Interactive comment on “Modeling the integrated framework of complex water resources system considering economic development, ecological protection, and food production: A practical tool for water management” by Yaogeng Tan et al.

Received and published: 8 January 2021

Dear referee #2:

Fig. 1.

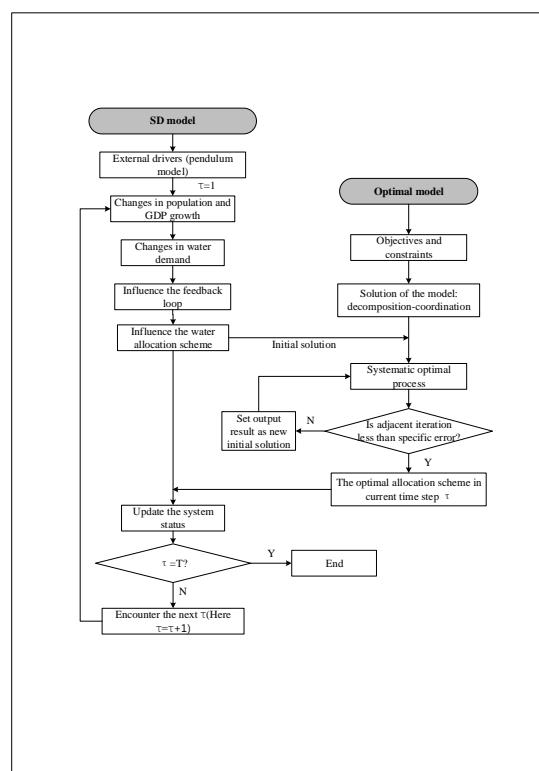
to "characterize" the real system or represent an ideal situation. If the goal is to characterize the real system, then a system dynamics model would be sufficient. Agents of a real system rarely optimize things. If the goal is to represent an ideal situation (in a neoclassical sense), then the optimization model would be sufficient. I believe this confusion arises because the goal of the modeling is not defined adequately. As the first reviewer explained, the relationships between the optimization and the SD model need to be clarified.

To couple both models, the initial scheme of water supply should be generated by SD model. We define each time step of external drivers as τ . For each τ , both water supply and demand can be calculated by SD model (For calculation of SD model, the equation of each variable can be seen in Supplementary data of the paper). The water supply scheme generated by SD is the initial solution of the optimal model (Li et al., 2018). The optimal solution (optimal water supply scheme) is generated by the iteration of the optimal model until the adjacent iteration result is less than a specific error. Then, the optimized water supply will transfer back to SD to update the system status of the

current time step, and prepare for the next τ and repeat the whole process. We define T as the total number of τ . If $\tau < T$, repeat the whole process; If $\tau = T$, end the process. The flowchart of the whole process is in the supplement of this reply.
